Subject: VIRGIL C. SUMMER NUCLEAR STATION (VCSNS) UNIT 1
DOCKET NO. 50-395
OPERATING LICENSE NO. NPF-12
SOUTH CAROLINA ELECTRIC & GAS COMPANY'S FIRST SIX-MONTH
STATUS REPORT IN RESPONSE TO MARCH 12, 2012 COMMISSION ORDER
MODIFYING LICENSES WITH REGARD TO REQUIREMENTS FOR
MITIGATION STRATEGIES FOR BEYOND-DESIGN-BASIS EXTERNAL
EVENTS (ORDER NUMBER EA-12-049) (TAC NO. MF2338)

Attachment I SCE&G's First Six Month Status Report for the Implementation of Order EA-12-049, Order Modifying Licenses with Regard to Requirements for Mitigation Strategies for Beyond-Design-Basis External Events

**SOUTH CAROLINA ELECTRIC & GAS COMPANY'S FIRST SIX MONTH STATUS
REPORT FOR THE IMPLEMENTATION OF ORDER EA-12-049, ORDER MODIFYING
LICENSES WITH REGARD TO REQUIREMENTS FOR MITIGATION STRATEGIES
FOR BEYOND-DESIGN-BASIS EXTERNAL EVENTS**

Figure 1 – Conceptual Phase 1&2 Coping for SG Feed Makeup

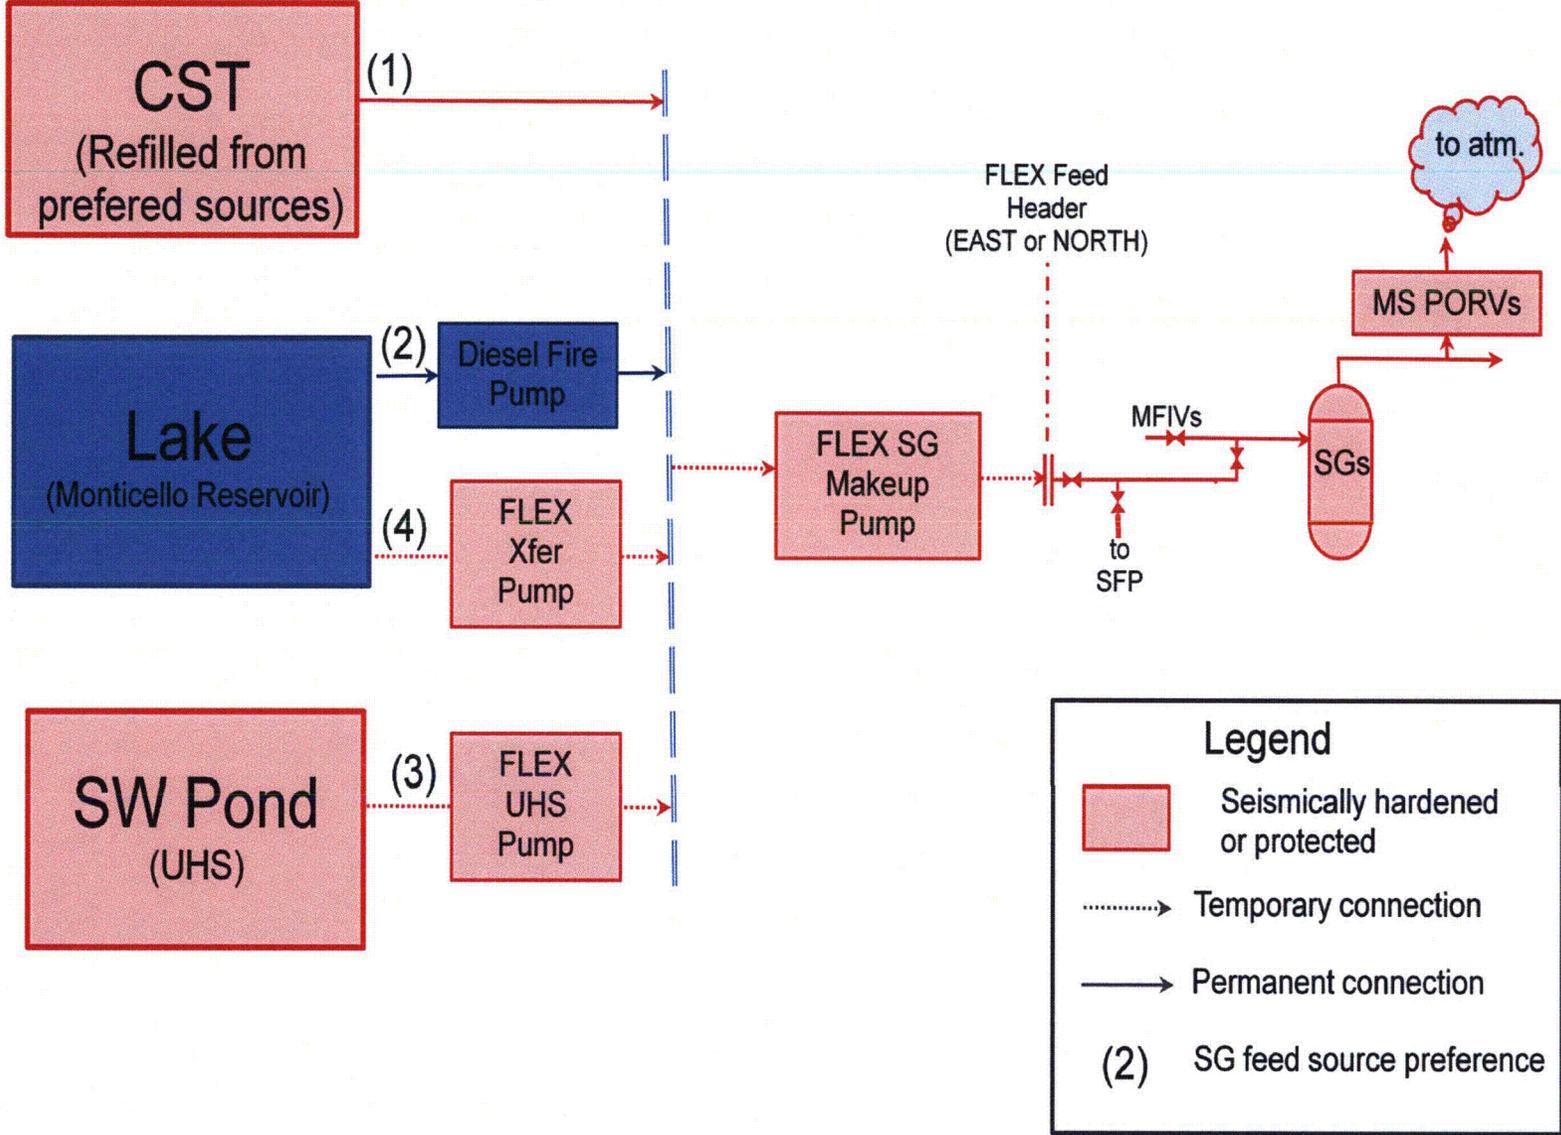
Figure 1 – Conceptual Phase 1&2 Coping for SG Feed Makeup was revised and reissued in Attachment II of this submittal. The significant changes to the figure are as follows: (1) removed reference to RBCUs located on the FLEX Feed Header and (2) changed the connection labeled “to SFP” to show it as a permanent connection.

Figure 2 – Conceptual Diverse Strategy for Supplying the FLEX Feed Header

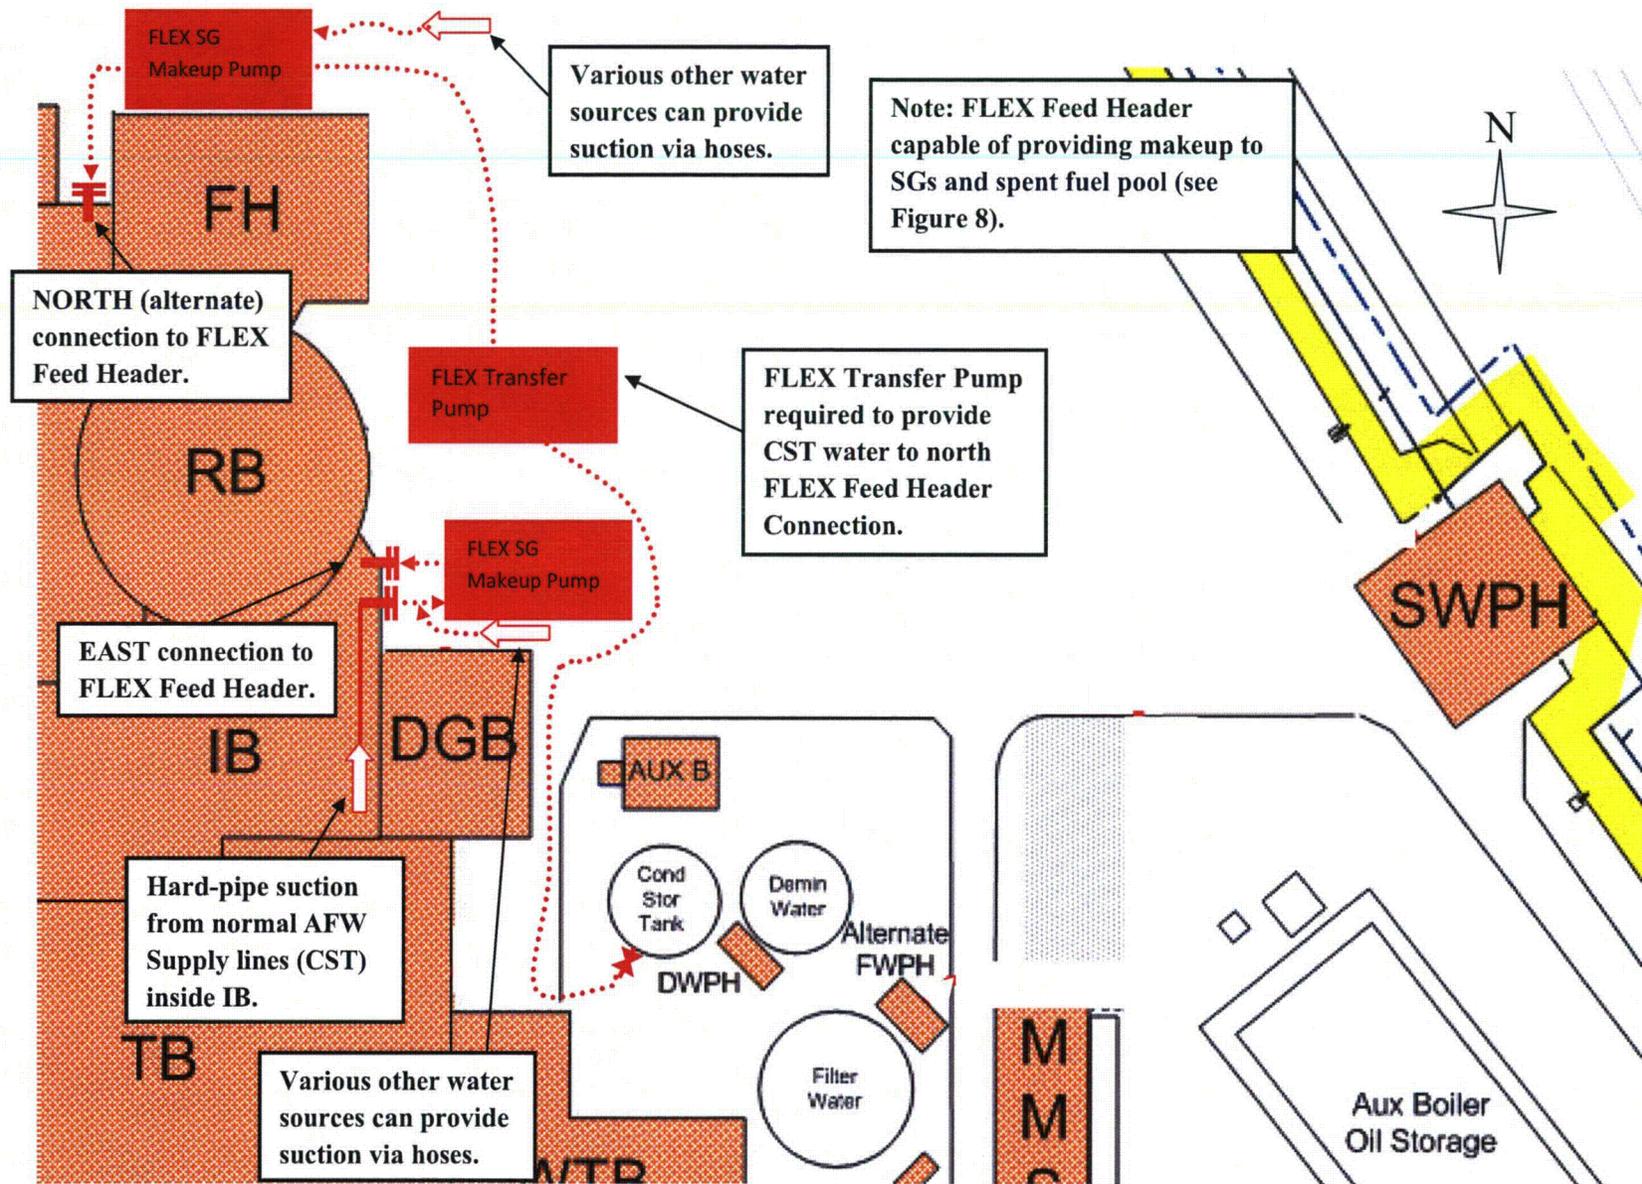
Figure 2 – Conceptual Diverse Strategy for Supplying the FLEX Feed Header was revised and reissued in Attachment II of this submittal. The significant changes to the figure are as follows: (1) identified the approximate deployment locations of the FLEX SG Feed Pumps; (2) identified that a booster pump is needed to provide suction to the North FLEX Feed Header when aligned to the CST; (3) identified the protected suction from the CST via Emergency Feedwater (EFW) as a strategy for the East FLEX Feed Header; and (4) identified clarified the location that other water sources would feed the FLEX SG Feed Pump suction.

Figure 4 – Conceptual Strategy for Reactor Makeup and Reactivity Control

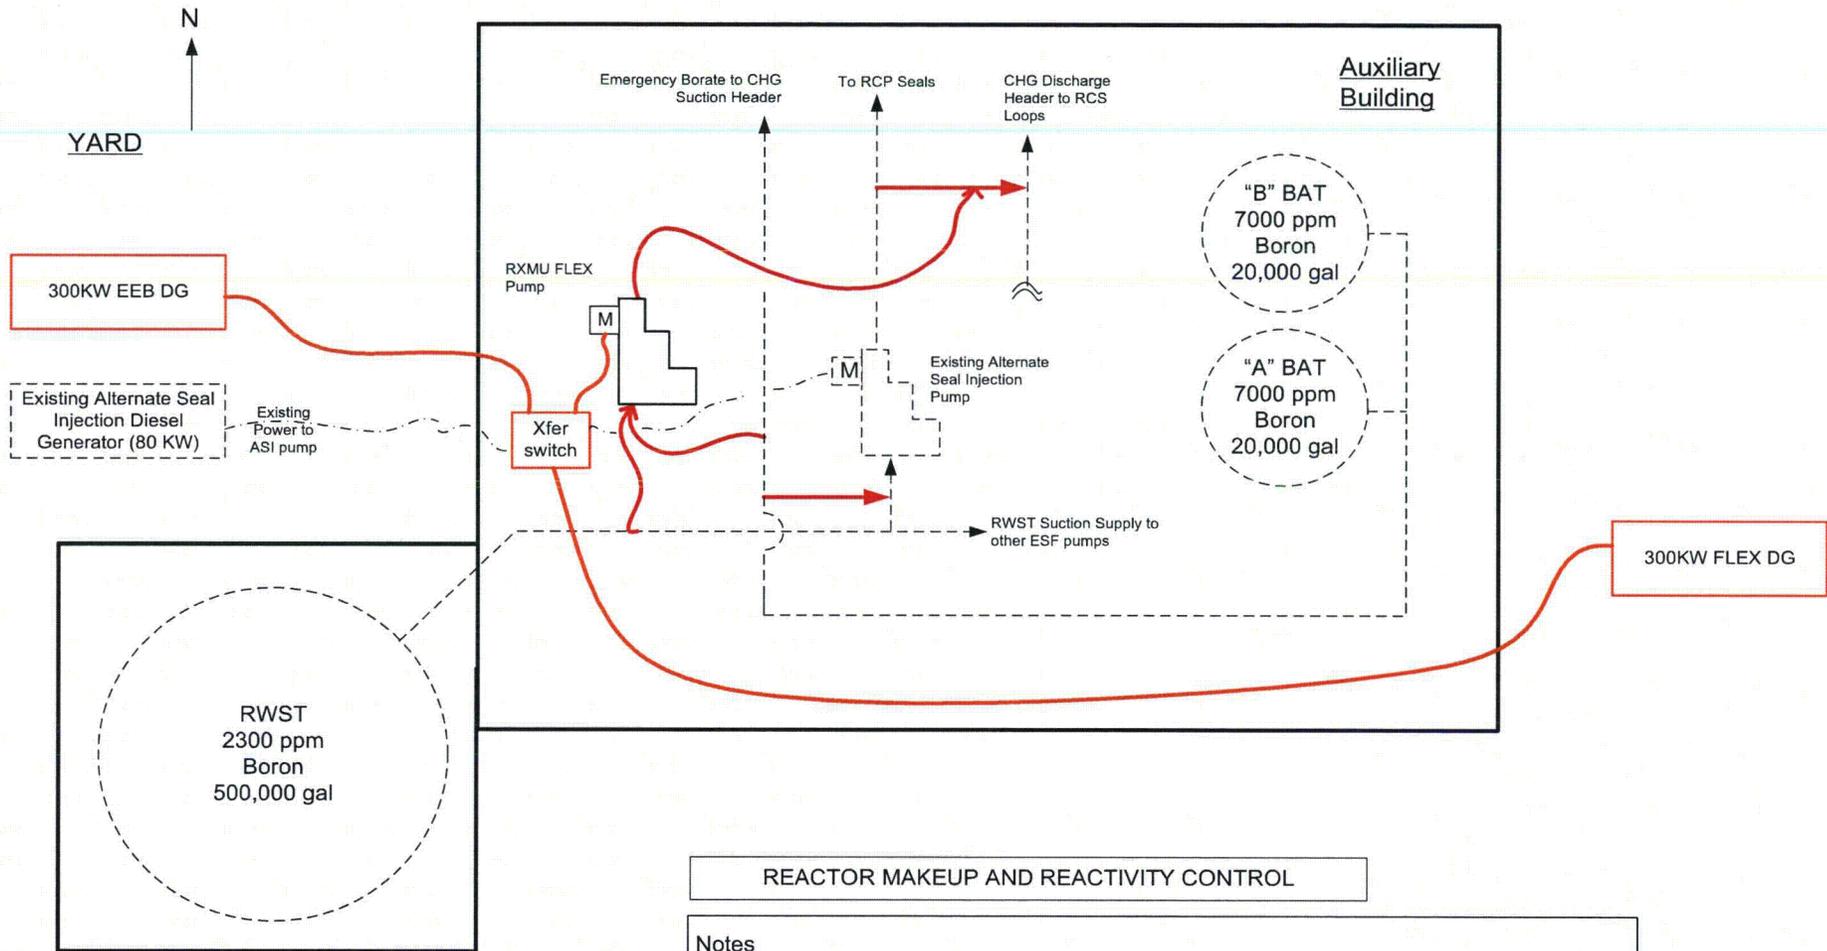
Figure 4 – Conceptual Strategy for Reactor Makeup and Reactivity Control was revised and reissued in Attachment II of this submittal. The significant changes to the figure are as follows: (1) reflected the size of the EEB DGs as 300 kW; (2) added the conceptual power source from the FLEX DG; and (3) added a reference to Figures 5 and 10 for clarity.

Figure 5 – Conceptual Coping Strategies for Support Functions from EEB

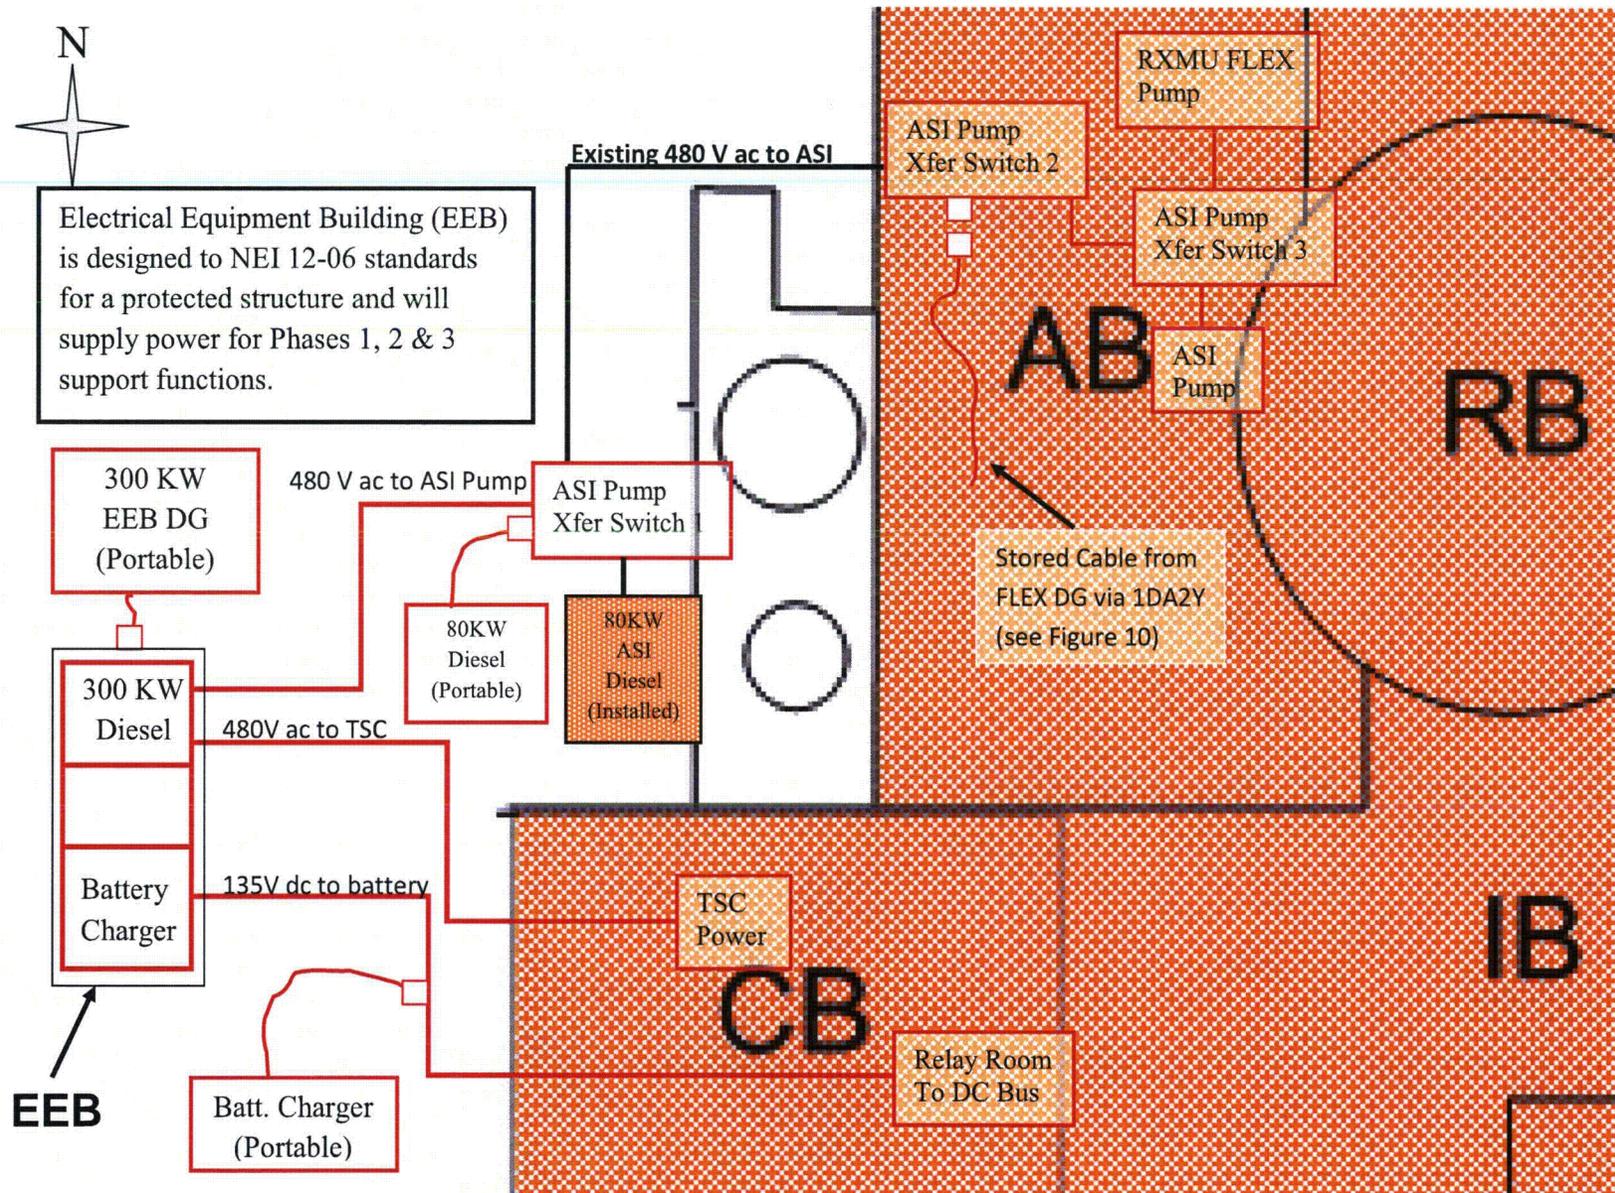
Figure 5 – Conceptual Coping Strategies for Support Functions from EEB was revised and reissued in Attachment II of this submittal. The significant changes to the figure are as follows:

(1) reflected the size of the EEB DG as 300 kW; (2) added additional details of transfer switches and connections; and (3) added the ASI/RXMU FLEX Pump power supply from the FLEX DG via 1DA2Y and temporary cable.

Figure 9 – Conceptual Phase 1 Coping Strategy to Repower Battery Chargers

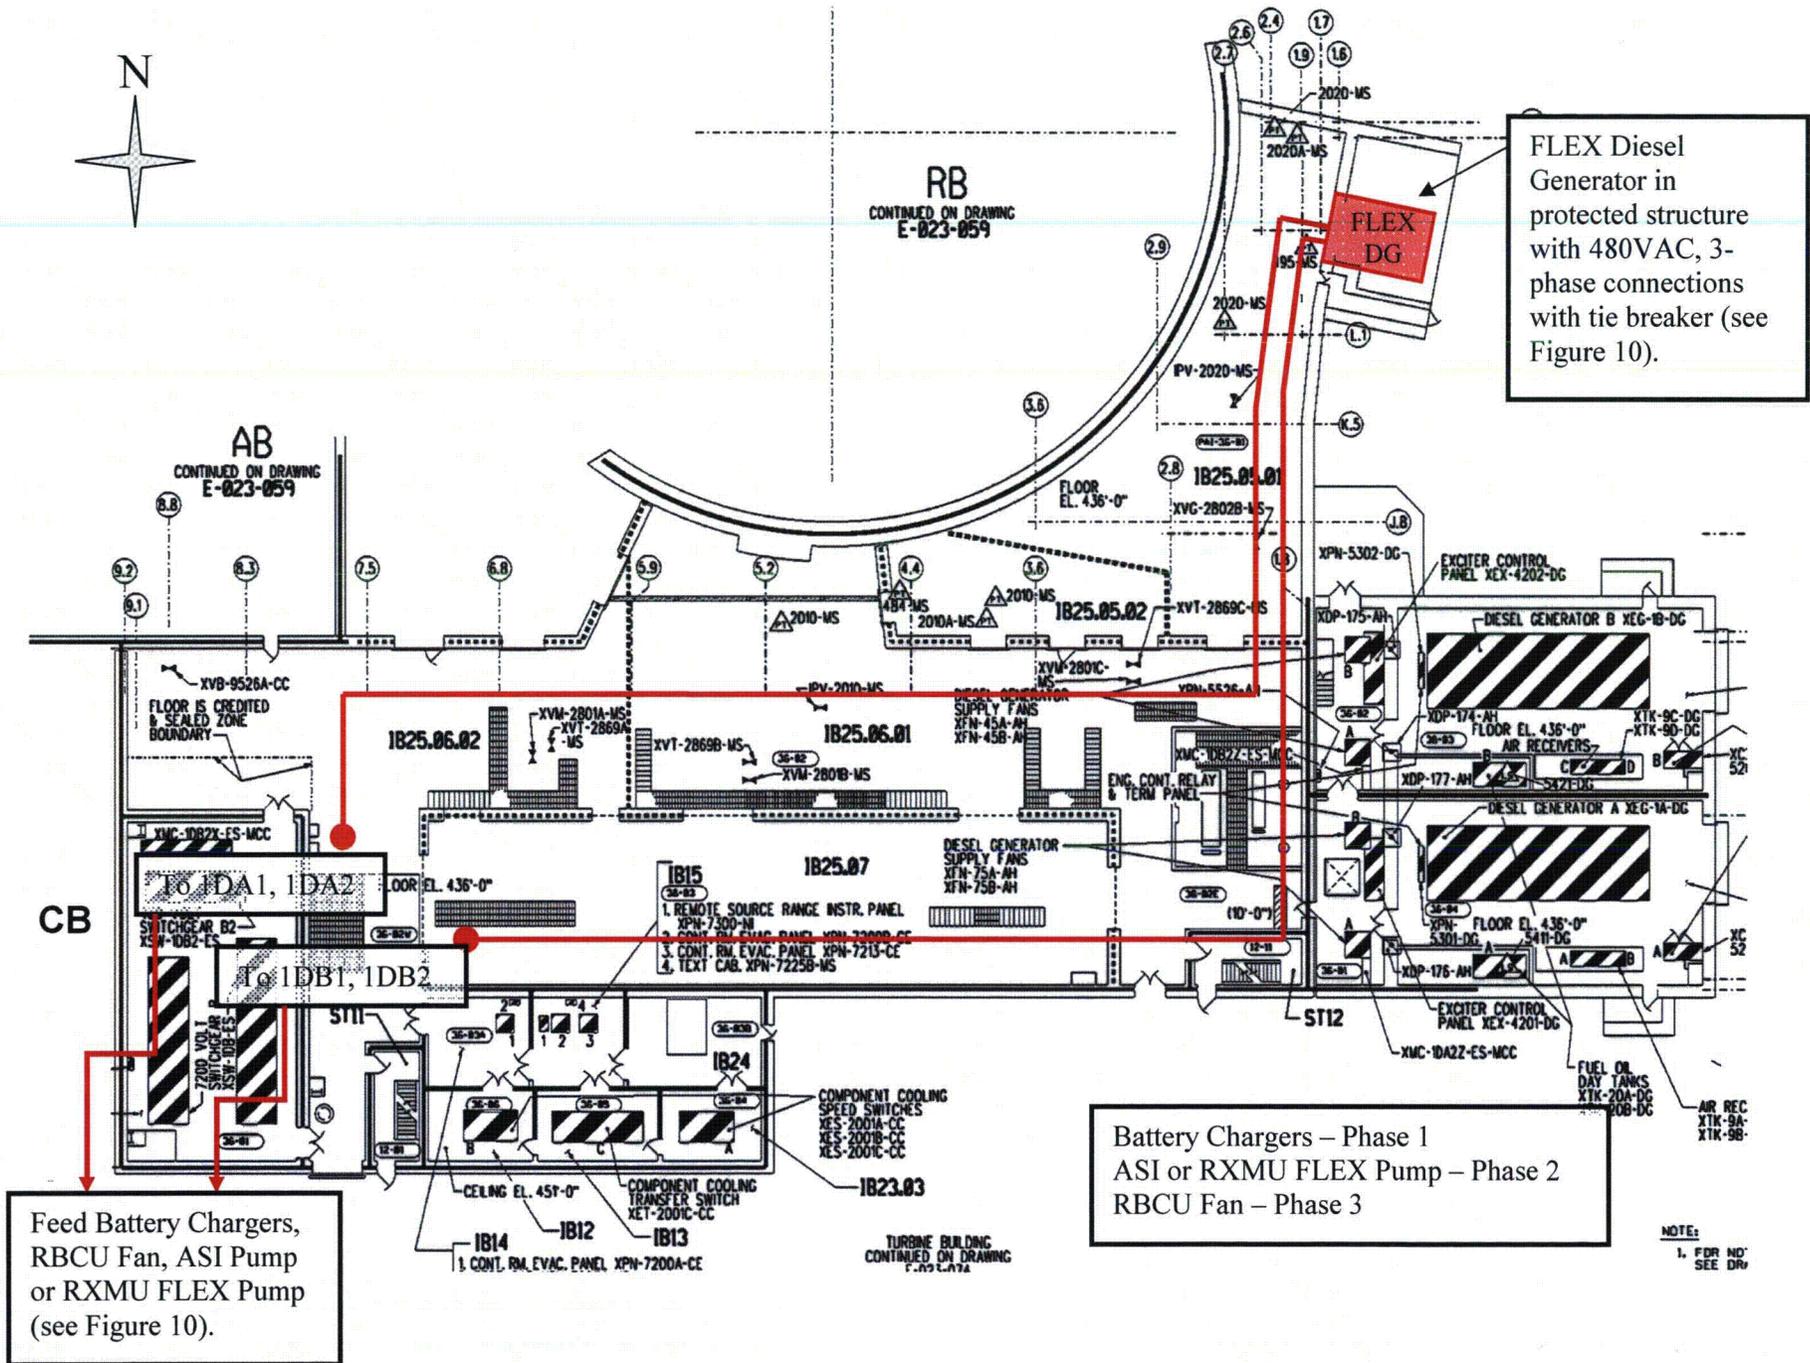
Figure 9 – Conceptual Phase 1 Coping Strategy to Repower Battery Chargers was revised and reissued in Attachment II of this submittal. The significant changes to the figure are as follows: (1) added additional electrical feeds from the FLEX DG to the RBCU Fans, ASI Pump, and RXMU FLEX Pump; and (2) added a reference to Figure 10 for clarity.
